CHANGE ORDER #2

Project: #1232.001 - RUSHMORE PLAZA
CIVIC CENTER MULTIPURPOSE
ADDITION - BID PACKAGE 2
Rapid City, South Dakota

Change Order No.: 2

Initiation Date: November 7, 2007

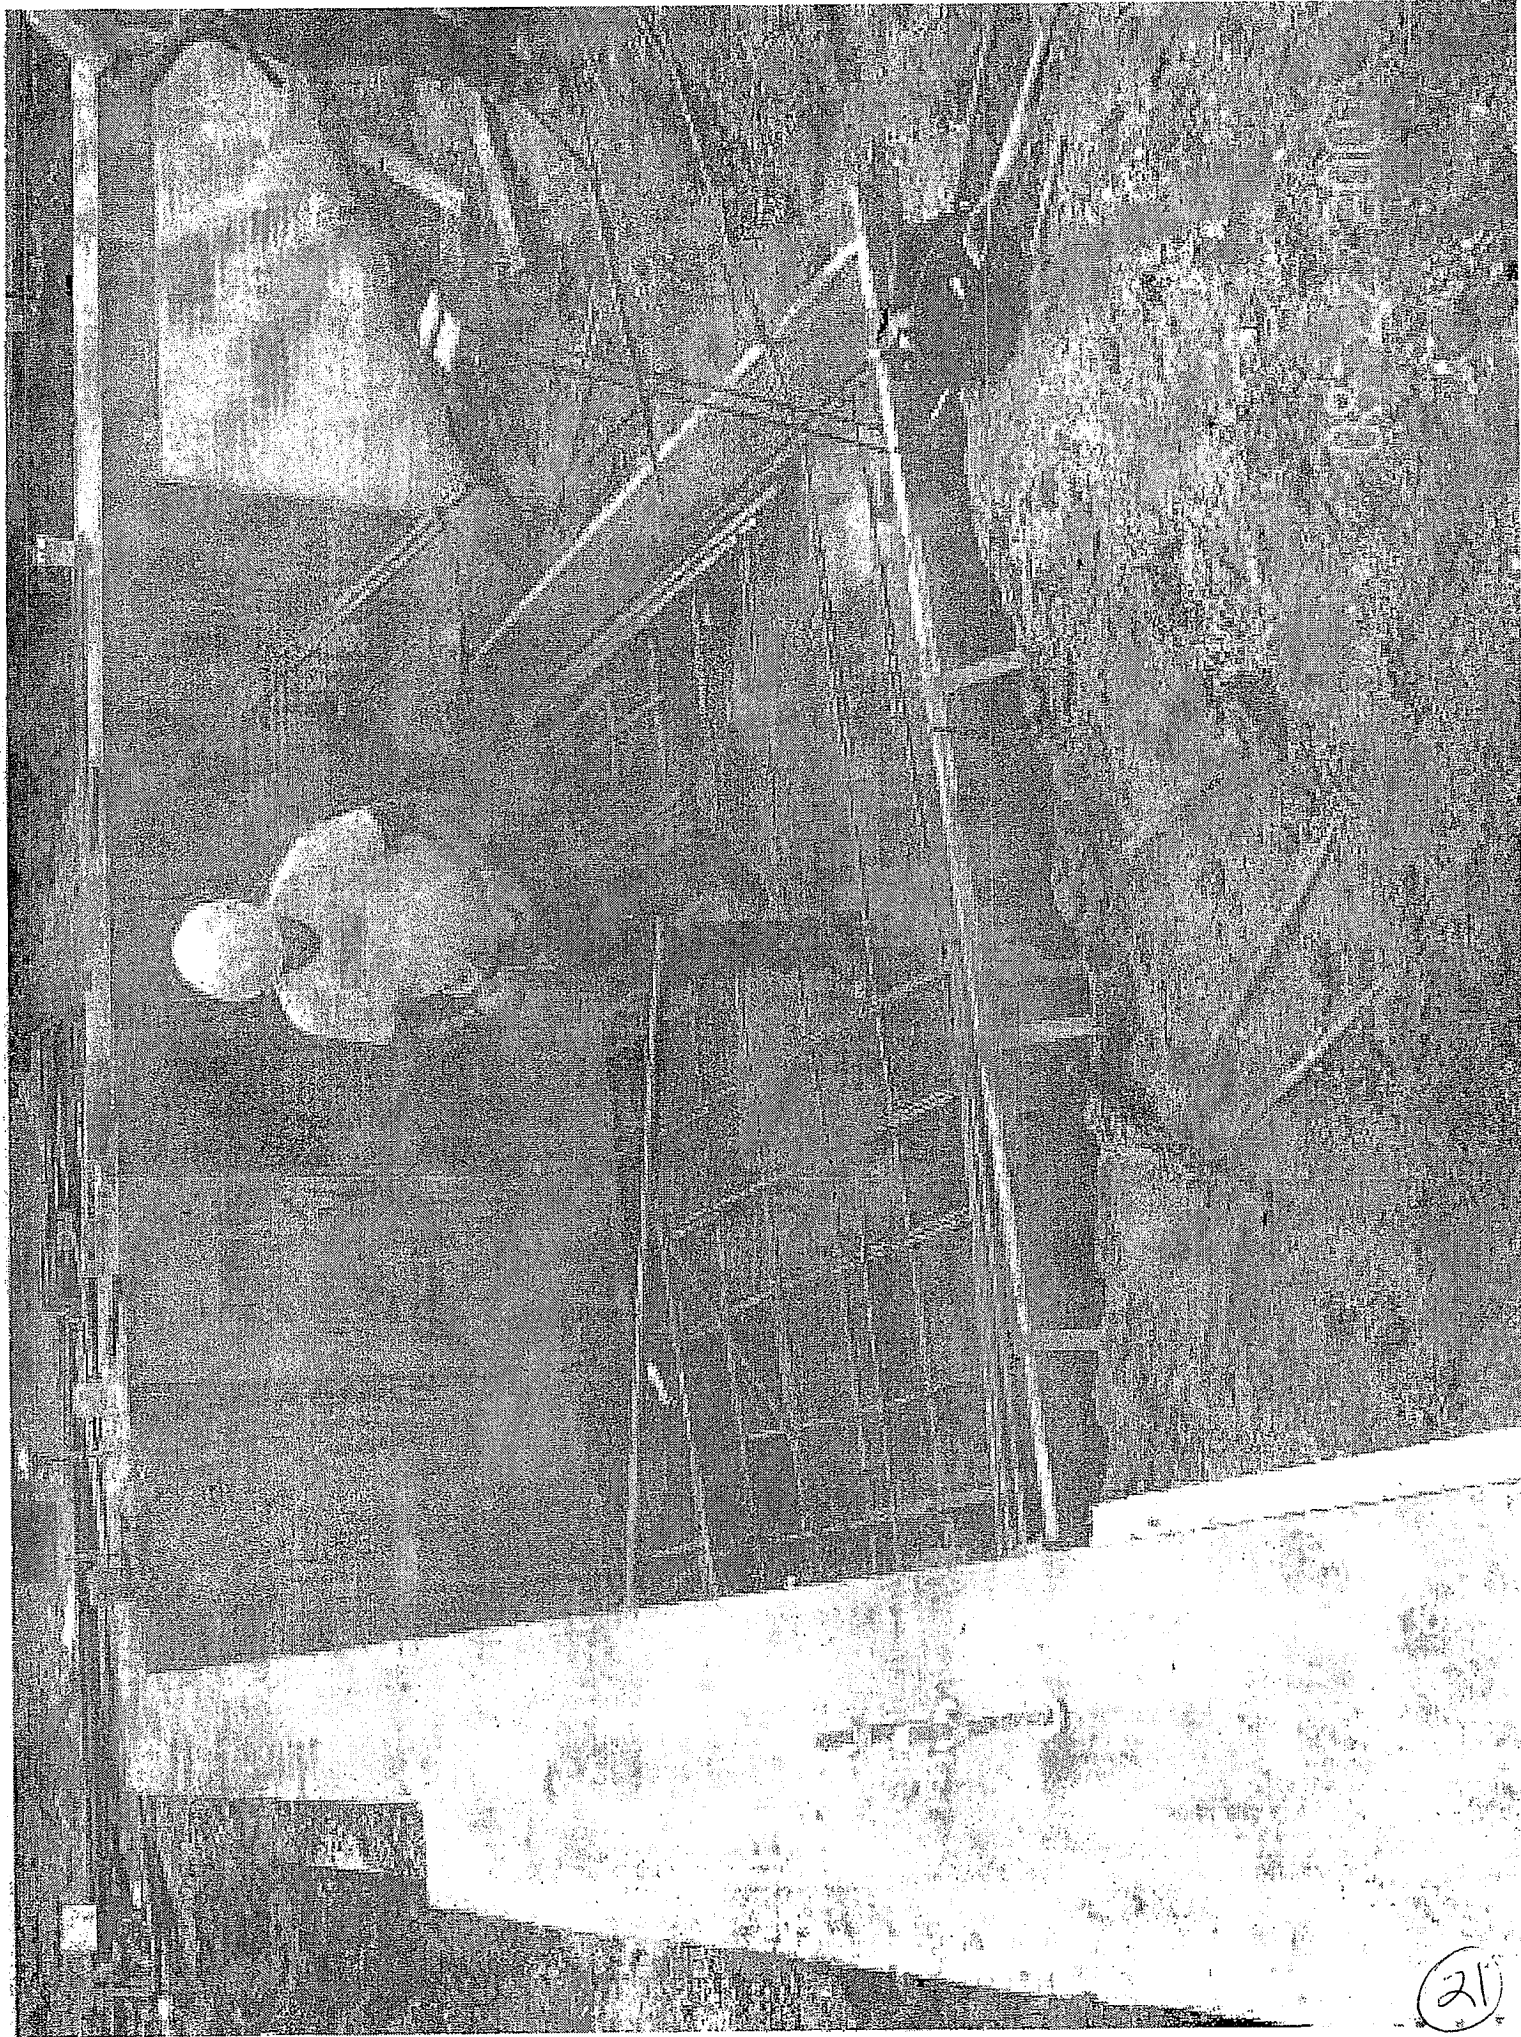
The two GB-2 grade beams that are shown on Sheet # S11.11 are shown to be existing, please advise as to how this should be handled. This appears to be part of Bid Package #1.

(3) #8 top and bottom bars

#4 tie at 18" cc

#5 horizontal midheight bars at 18" cc each face
